**ADDENDUM TO RFP DOCUMENTS**

<b>SOLANO</b> COMMUNITY COLLEGE 	ADDENDUM #01
	Project: #16-015 Solano Community College District Site Lighting Improvements Project
	Date: March 29, 2016

**ITEM NO. 1 – PLAN SHEET 0.00 – COVER SHEET, INDEX**

PV POLE LOCATIONS  
ALTERNATE #3

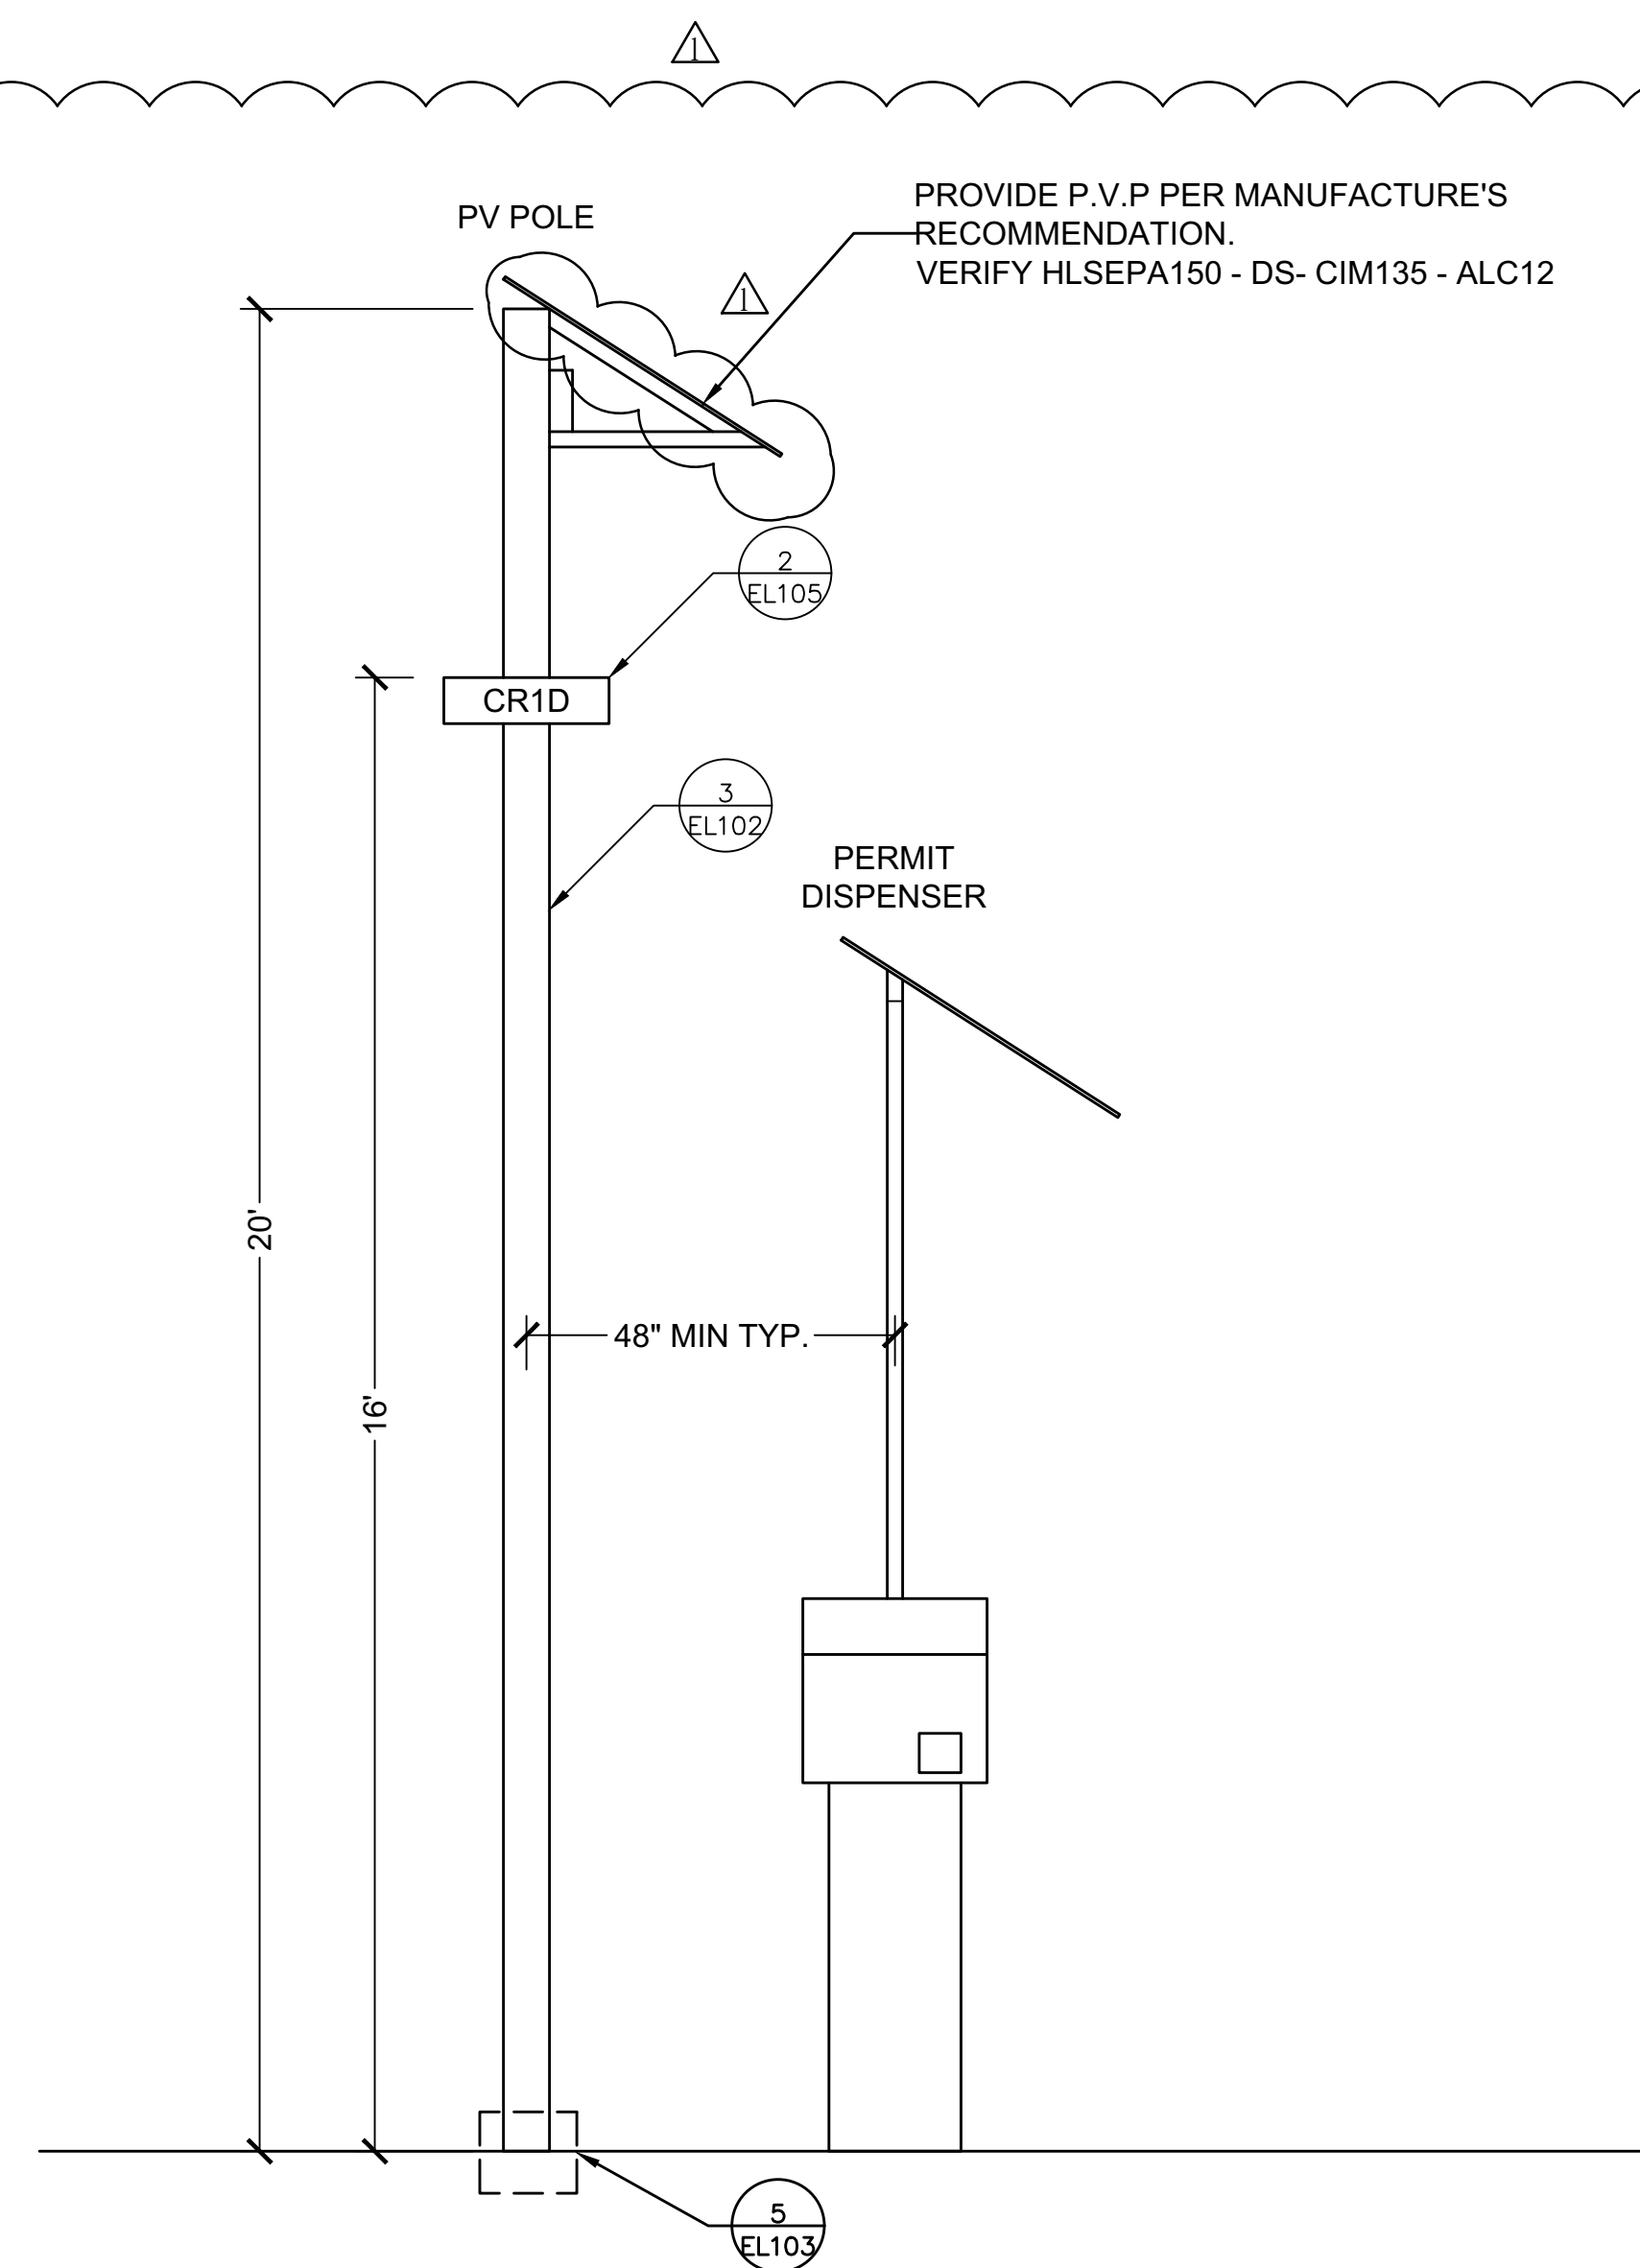
**ITEM NO. 6 – PLAN SHEET EL 104 – PV POLE LIGHT LOCATIONS (ALTERNATE #3)**

Include the attached 'Plan Sheet EL 104 – PV POLE LIGHT LOCATIONS (ALTERNATE #3)' into Contract Bid Documents. Added sheet identifies 'Alternate #3', to include:

- Furnishing and installation of six (6) standalone photovoltaic lights for parking permit dispensers, including pole/standard, footing/base support, solar power assembly and associated hardware.
- Scope of work for photovoltaic lights shall include all materials, labor and testing for a complete and fully operational system.
